IEC/IEEE
80005-1:2019/
FDAM 1

AMENDMENT 1

Utility connections in port —

Part 1: High voltage shore connection (HVSC) systems — General requirements

Figure C.4 – Three-phase ship connector and ship inlet contact assignment

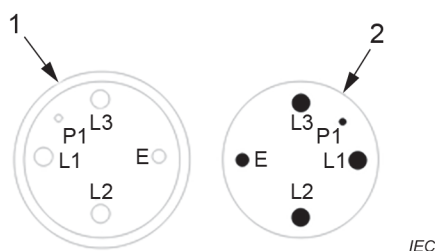
Replace the existing figure and key with the following new figure and key:

Key

- 1 Ship connector face
- 2 Ship inlet face
- E Earth
- P1 Pilot line 1 (used for continuity check)
- L1 Phase A – phase R
- L2 Phase B – phase S
- L3 Phase C – phase T
